Peach Bottom Atomic Power Station, Units 2 and 3
Renewed Facility Operating License Nos. DPR-44 and DPR-56
NRC Docket Nos. 50-277 and 50-278

Subject: Response to NRC Audit Review Information Request – Application for Subsequent Renewed Operating Licenses – Section 4.6 Primary Containment Fatigue Analyses

**Response to NRC Audit Review Information Request – Application for Subsequent
Renewed Operating Licenses – Section 4.6 Primary Containment Fatigue Analyses**

Below is an outline sketch of the strainer modules and how they are supported and attached at the torus shell.

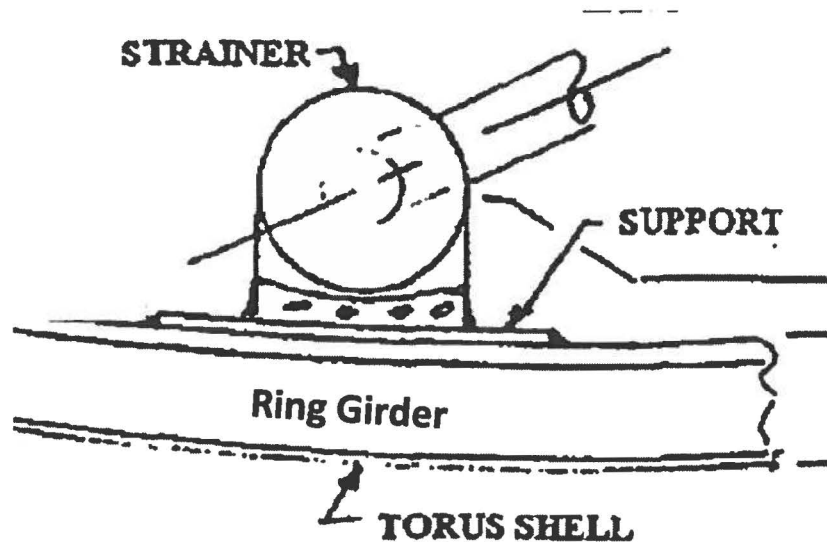
Question 9: - It is not clear whether the strainer supports referenced in Section 4.6.1 of the PBAPS SLRA include linear elements and if so, how the noted CUF of 0.661 applies to such elements.

The replacement RHR and Core Spray suction strainers were installed in 1997 and 1998 and were designed per ASME Section III, 1980 through the 1981 Winter edition, Subsections NC, NE, and NF. These strainers are bolted cylindrical screen modules with internal supports, ribs, and stiffeners that are flanged to existing system piping. The cylindrical strainer modules are supported at the support legs which attach the strainers to the torus shell ring girders.

The strainer modules, including the flanges to the system piping flanges, were designed to Section III Subsections NC and NE. The support legs which attach the strainers modules to torus shell ring girders were designed per Section III Subsection NF.

The strainer design included finite element modelling of the strainer modules, including the terminations points at the system piping flanges and the strainer support legs. Therefore, "Linear Type Supports" were evaluated both within the strainer modules and in the support legs. The resulting stresses from the finite element model were reviewed and the nodes on the models with the greatest alternating stress were evaluated for fatigue.

The usage of the support legs was concluded to have a CUF value of 0.661. This was based on the assumptions of:

- 1) 800 SRV Lifts, with each lift resulting in 13 loading cycles for a total of 10,400 loading cycles, and
- 2) 5 Design basis events which includes a DBA during an OBE with SRV lifts, with each event resulting in 9 loading cycles for a total of 630 loading cycles.

Therefore, the strainer support fatigue analysis assumed 11,030 loading cycles which does not exceed 20,000 cycles.
